Response to Comments From the Colorado Department of Public
Health and Environment on the New Rifle Vanadium Pilot
Treatment Performance Report

From: Wendy Naugle

Figure 1. Results of MT3D model predictions using the maximum, average, and minimum K_d values measured for the site.

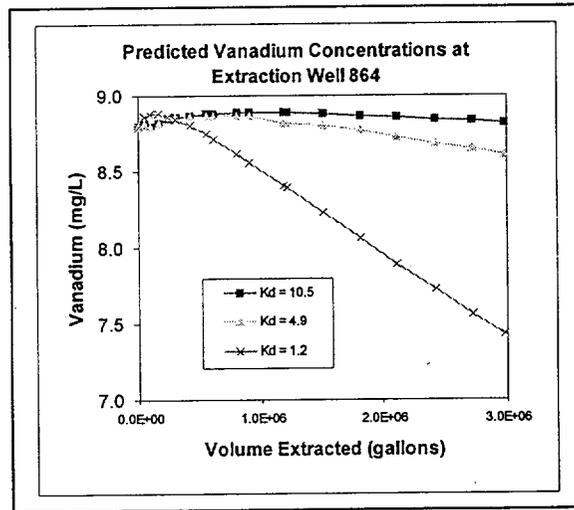
A more detailed evaluation of the extraction system is needed. This evaluation should include: (a) calculation of the mass of vanadium removed versus the mass remaining at the site, and (b) review of vanadium concentrations in other nearby monitor wells. In addition, (c) the hydraulic performance of the system should also be evaluated, which would include review of drawdown data, drawing a capture zone and (d) comparing the results of the extraction system with the numerical model predictions.

Response (d): The numerical model MT3DMS (McDonald and Harbaugh, 1988) was used to evaluate the amount of vanadium in the groundwater plume that could be expected to be recovered during the pilot test as a function of the linear distribution coefficient (Kd) and the volume extracted. The Kd (L/Kg) is equal to the first-order, sorption constant that describes the linear partitioning between the soil (mg/Kg) and groundwater (mg/L). A relatively high Kd value favors partitioning to the soil (i.e. immobile phase) while a relatively low Kd favors partitioning to the groundwater (i.e. mobile phase). The linear Kd retardation model assumes the system is in equilibrium between the solid and aqueous phases and does not account for the rate of mass-transfer between the soil and groundwater. Characterization results of vanadium contamination from soil and groundwater samples suggest a disequilibrium condition currently exists at the site (DOE 2000). However, for a first approximation, the bulk Kd parameter is used to describe the retardation of contaminant transport. For this modeling exercise, the actual Kd values obtained for the maximum (10.5), average (4.9), and minimum (1.2) measured

at the New Rifle site (DOE 1999) were used as input parameters. Simulations were performed at a nominal extraction rate of 10 gpm at pumping well 864. A continuing source of groundwater contamination in the subpile soil area was not modeled. Modeling results after extracting 3 million gallons of the soluble plume are shown in Figure 1. The simulations reveal that using the maximum K_d (10.5) the vanadium concentrations in the soluble plume at the pumping well can be expected to increase from the initial 8.80 mg/L to 8.82 mg/L, reflecting a rather stable concentration. Only a slight decrease to 8.61 mg/L is predicted using the average K_d (4.9). A significant decrease to 7.43 mg/L is predicted using the lowest K_d (1.2). The concentration increase observed for the lowest K_d that peaks after approximately 150,000 gallons of volume has been extracted reflects capture of the highest vanadium concentration located in the core of the soluble plume. This concentration "peak" is delayed and flatter for the higher K_d s due to the greater partitioning to the solid phase. The greater partitioning to the solid phase results in relatively slower contaminant transport and explains the more stable vanadium concentrations.

Figure 3. Vanadium Concentrations Versus Two Different Pump Rates.

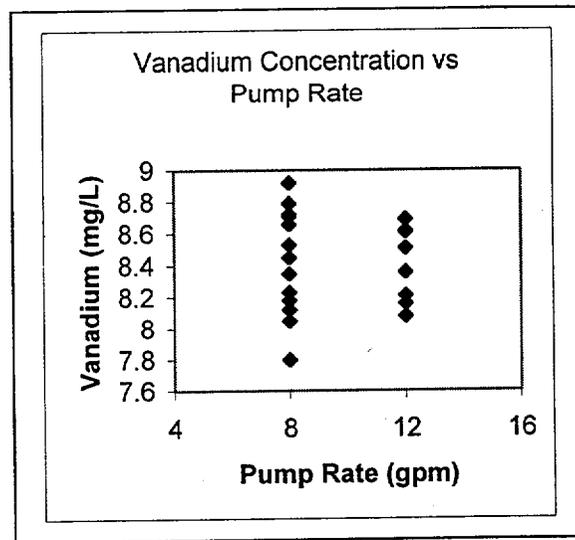
- (g) Is it because the V was being immobile? If so, would varying the pumping rates give us info to verify the hypothesis (if immobile, concentrations should decrease with increased flow rates).

Response (g): The reviewer suggests that if vanadium is immobile then reduced concentrations should be correlated with increased flow rates and varying the pumping rates can test the hypothesis. Even though the pump rates were not varied during the pilot test to specifically address this hypothesis, examining the pump rates plotted in Figure 4-7 of the Performance Report can provide some insight. It is apparent from Figure 4-7 that the pump rates varied considerably during the pilot test. Considering one example, the pump rates were maintained constant at approximately 8 gpm from April 25 through May 14. The pump rates then increased to approximately 12 gpm and were maintained constant at this rate from May 21 through May 29. Vanadium concentrations versus the two different pumping rates are shown in Figure 3. No correlation between vanadium concentration and pump rate is apparent. In addition, the vanadium concentration during the 8 gpm period (April 25 through May 14) averaged 8.4 mg/L and during the 12 gpm period (May 21 through May 29) the concentrations also averaged 8.4 mg/L, indicating no significant difference in concentrations due to varying the pumping rates.

Figure 4. Vanadium Concentrations in Effluent from Column Experiment.

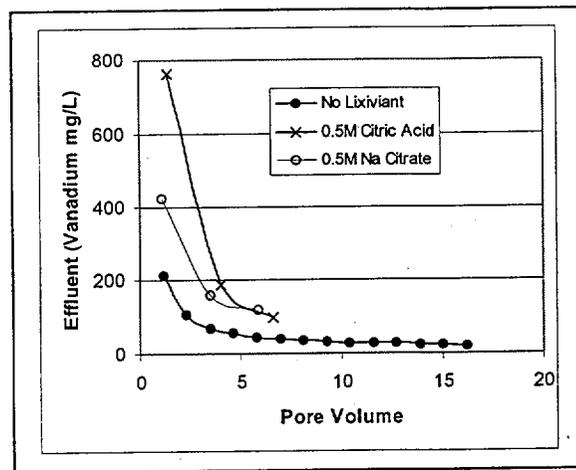
- (h) Would adding a lixivient verify the hypothesis by showing greatly increased concentrations at all pumping rates?

Response (h): The reviewer suggests that adding a lixiviant should result in greatly increased concentrations thereby verifying the hypothesis that vanadium is immobile. This hypothesis was tested at the DOE ESL by a column experiment using contaminated subpile soil collected from 8 to 10 ft below ground surface adjacent to monitor well 658. The vanadium concentration measured in the subpile soil sample was 857 mg/Kg (DOE 2000). Background groundwater collected from up gradient monitor well 215 was used as influent to the column filled with subpile soil. Three column tests were conducted; no lixiviant, 0.5M citric acid, and 0.5M Na citrate. Results of the column experiment are presented in Figure 4.

Evident from the data presented in Figure 4 are greatly increased vanadium concentrations at the beginning of the experiment using the two test lixiviants, as the reviewer suggested. Vanadium concentrations decreased by a factor of 4 using 0.5M Na citrate and by a factor of 8 using 0.5M citric acid after approximately 6 to 7 pore volumes, respectively. Concentrations decreased by approximately a factor of 5 using no lixiviant after a similar pore volume exchange.

It is also of interest to note that the rate of decrease in vanadium concentration observed using no lixiviant was greatly reduced after 5 to 6 pore volumes (Figure 4). This “tailing effect” suggests the partitioning between the solid and aqueous phase is not at equilibrium and that the linear K_d sorption model may not apply. The decrease in the rate of mass-transfer between the soil and groundwater phase observed in the column experiment may help explain the relatively stable concentrations (i.e. “tailing effect”) observed at extraction well 864.
